## SERVICE INFORMATION NO. SI D4-073/1

GARMIN Service Alert 070801-01  
ATA-Code: 34-00

**Service Alert: 070801-01**

#### **REVISION B: Revised Affected Products and Aircraft Section**

**Figure 1. Engine System Display (Typical)**

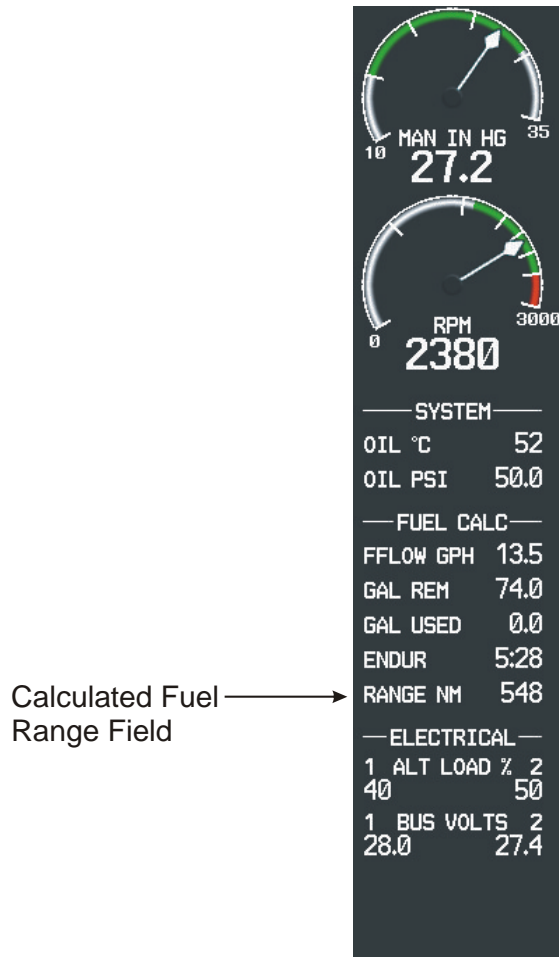
Affected aircraft use a Calculated Fuel Range Field (Figure 1) that works correctly only when the Distance/Speed Display Unit Field on the AUX - System Setup Page is set to NAUTICAL (NM, KT) (Figure 2).

When the Distance/Speed setting on the AUX System Setup Page is changed to METRIC (KM, KPH), the Calculated Fuel Range Field on the Engine System Display is inaccurate. This may cause the pilot to mistakenly believe he can fly farther than is possible on the remaining fuel.

GDU software V8.20 or later incorporates a change correcting the issue. Until GDU software V8.20 or later is installed, the pilot should select NAUTICAL (NM, KT) Display Units for Distance/Speed on the AUX System Setup Page (Figure 2). Instructions on changing the Distance/Speed Units are in the Pilot's Guide and Cockpit Reference Guide for the aircraft listed in this Service Alert.
